UNITED STATES PATENT AND TRADEMARK OFFICE

10/551,089

Office Action Summary	Application No. 10/551,089	Applicant(s) DI GIACOMO ET AL.	
	Examiner NURI ALTUN	Art Unit 3657

DETAILED ACTION

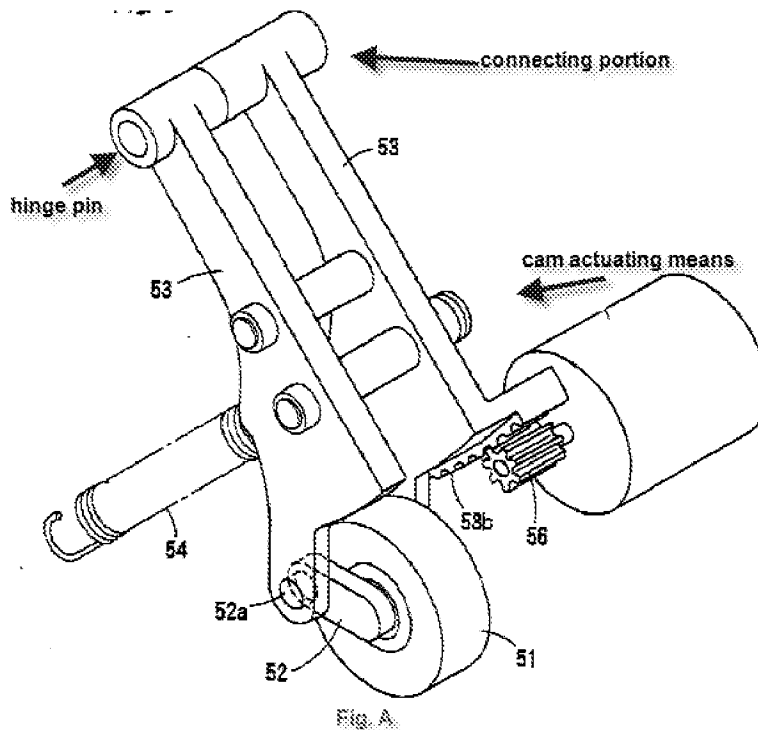
Temma et al. teach a stepless speed change unit having an electric motor (55) which can be activated to exert a force in opposition to that exerted by said elastic means (54), to detach a drive wheel (51) from a drive member (15) (paragraph 0064; since the motor is capable of being reversely driven to subtract tension from the initial tension supplied by the spring, the motor can be reasonably considered as being

capable of detaching the drive wheel from the drive member by the motor applying a greater tension than that of the spring), and the electric motor (55) is reversible such that, when said elastic means exert a force, to push said drive wheel (51) against said drive member (15), which is greater than the travel resistance of said motor when maintained in a disabled rest condition, said force overcomes the resistance of the electrical rotary motor (see Fig. 3, paragraph 0063 lines 9-14 and paragraph 0064; the spring keeps the drive wheel in contact with the belt by overcoming the motor's resistance when the motor is not operating).

Temma et al. teach a mechanical drive (56 and 53b) interposed between actuating means and said movable supporting member (53) (Claim 4), movable supporting member comprises a connecting portion, opposite the drive wheel, connected to mechanical drive, to move along a circular trajectory (see Fig. A) (Claim 5), and said mechanical drive comprises a gear drive (56) interposed between the electric rotary motor and said movable supporting member (claim 6), and mechanical drive comprises cam actuating means (see Fig. A) (Claim 7) interposed between said gear drive and said connecting portion (see Figs. A) (Claim 8).
